Migrating from STR91xF to STR91xFA

This document describes at the system level the feature enhancements and silicon fixes incorporated in the new STR91xFA devices, compared to the original STR91xF devices.

Figure 1. Memory accelerator

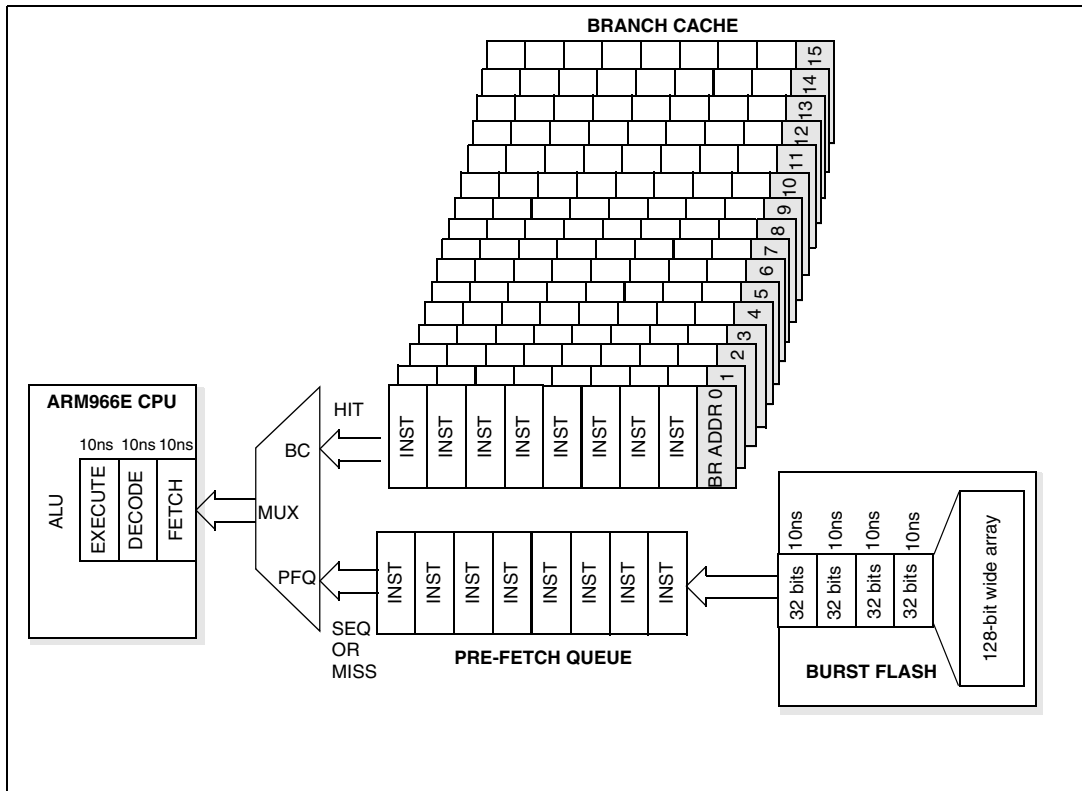
In STR91xFA, the number and size of branch cache entries was increased from five entries with four words each to 16 entries with 8 words each. The 16 entries are partitioned into 15 general purpose entries plus one entry dedicated to the VIC. The branch cache serves to accelerate instruction fetching from the burst-mode flash memory in looping code.

In STR91xF, the FMI_CR register bit 0 is used to define the PFQ FIFO size (4 or 8 words). In STR91xFA this bit becomes a "don't care" bit. The PFQ FIFO size is always powered up as 8 words. The change in FIFO word size will have no impact on your system operation.

Impact: Performance enhancement. Fewer wait states will be incurred in response to program branches taken repeatedly. Aside from the performance improvement, the change is completely transparent to both systems and application software.
